## **ATTACHMENT A – S.96 MODIFICATION PLANNING REPORT**

The S.96 Modification is in relation to the Stage 1B Mountain Bike Trails, DA 6751 as modified under MOD 7493 (Mod 1).

The proposed modification relates to seeking an alternate alignment for Trail 12 (Downhill Link), located between Trail 13 and the start of the Downhill and Flow Trails, adjacent to the Snowgums Double Chairlift top station.

#### **Trail 12 – Downhill Link:**

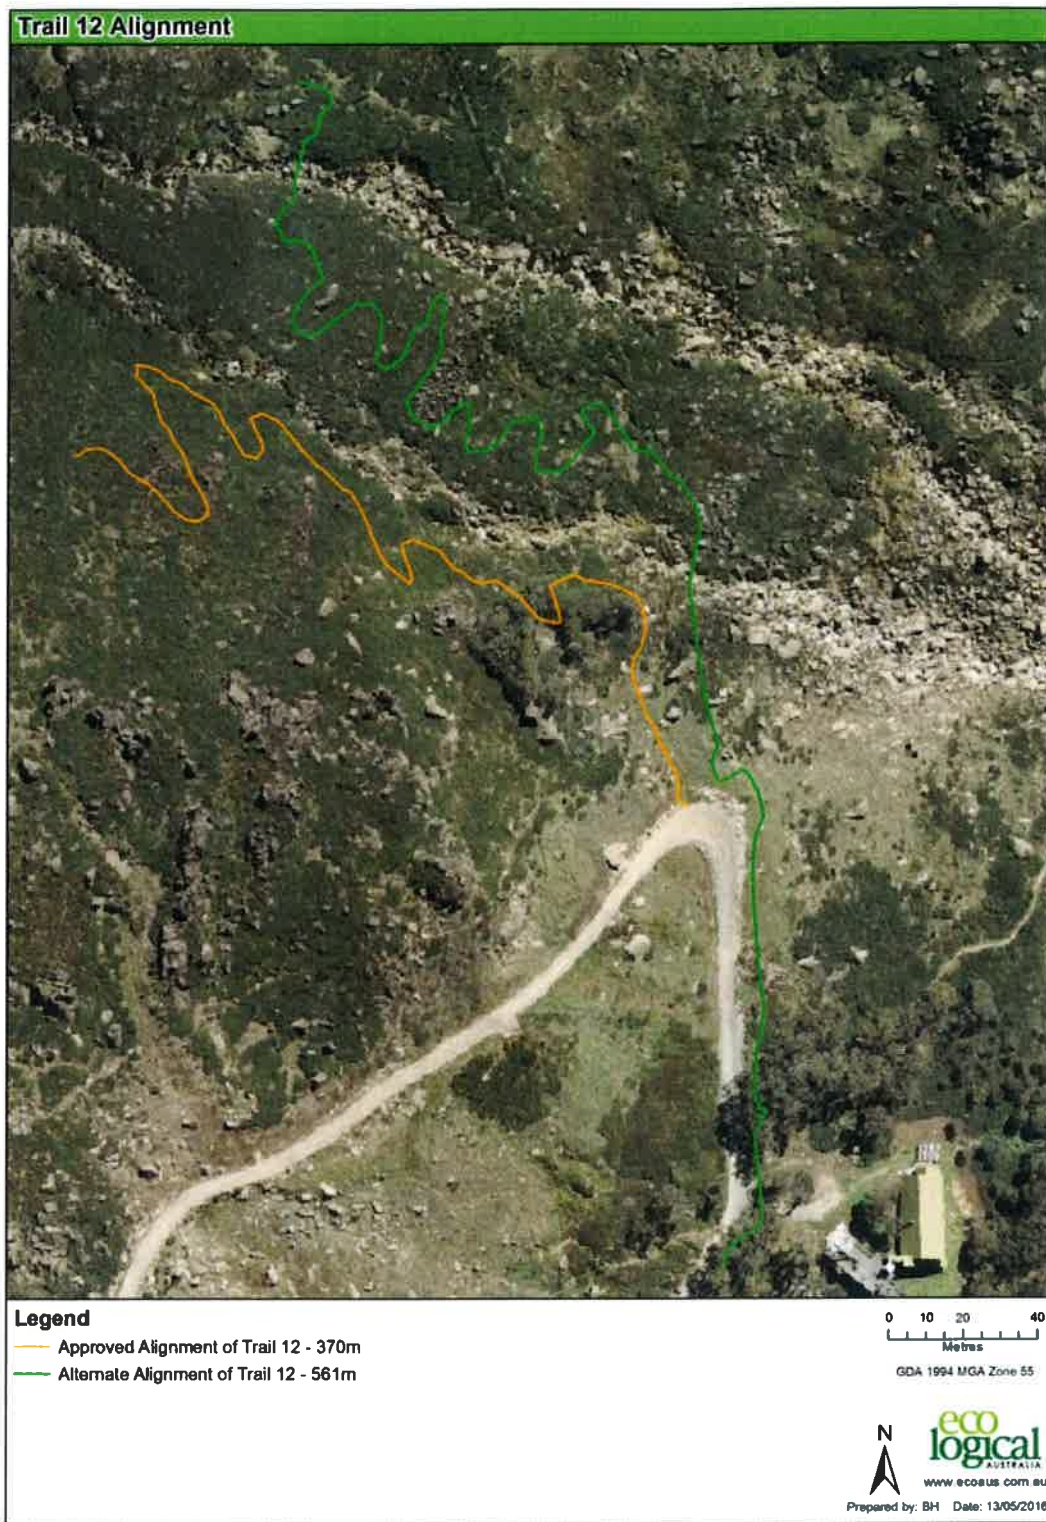
To reduce the slope of the trail and overall average grade, which was raised as a concern, the trail is proposed to be re-aligned so that it commences further along Trail 13 and therefore traverses more across contour at a longer length, requiring the installation of two bridges across Merritts Creek.

The bridges will be the same as approved for the Trail 13 bridge, constructed using the same method.

Whilst the length of the modified trail will be longer than the approved trail, the approved trail was designed to also use the side of the Summer Road down to the start of the Downhill and Flow trails, so its actual length would have been more likely 510m rather than 370m as shown below. Therefore the difference in the two trails would be more likely around 50m.
